KP412/ BB Cable Guide

About this Service Bulletin

Figure A.

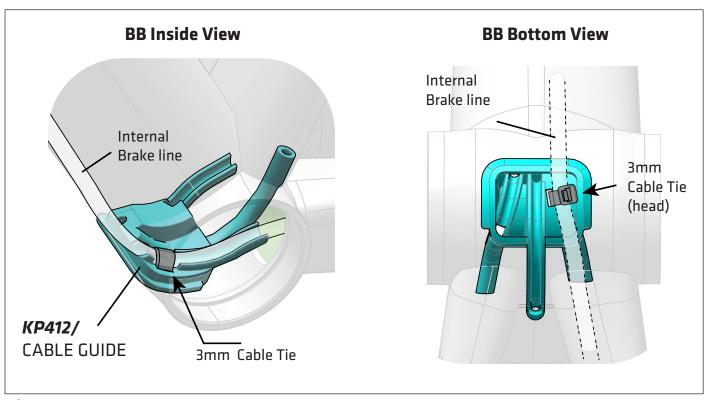
Secure the brake line to the **KP412**/ cable guide using a 3mm cable tie as shown in Figure A .

Secure the brake line to the KP412/ cable guide using a 3mm cable tie as shown in Figure A The brake line must not rub the crank spindle. If the brake line rubs the crank spindle, it could cut the spindle and lead to a fall and possible injury.
